Proposal for amendments to the 01 series of amendments to Regulation No. 67 (Equipment for Liquefied Petroleum Gas)

The text reproduced below was prepared by the expert from the European Liquefied Petroleum Gas Association (AEGPL) to insert new safety provisions into UN Regulation No. 67 on Liquefied Petroleum Gas (LPG) systems having hydraulic interconnections with the petrol or diesel fuelling system through which inter-flows of fuels may occur. It is based on ECE/TRANS/WP.29/GRSG/2015/35, taking into account the comments received by GRSG during its 109th session. The modifications to the current text of Regulation No. 67 are marked in bold characters.

"Annex 2A - Appendix 1

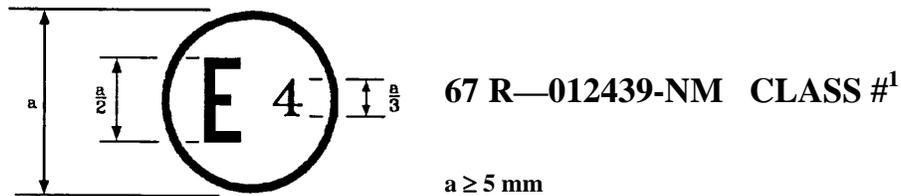
Arrangement of the type-approval mark of non-metallic, metallic or a mixture of metallic and non-metallic LPG components and LPG components containing non-metallic, metallic or a mixture of metallic and non-metallic parts compatible with petrol. The letter N indicates non-metallic components. The letter M indicates metallic components. The letters NM indicates a combination of metallic and non-metallic components. (See paragraph 6.17. of this Regulation)
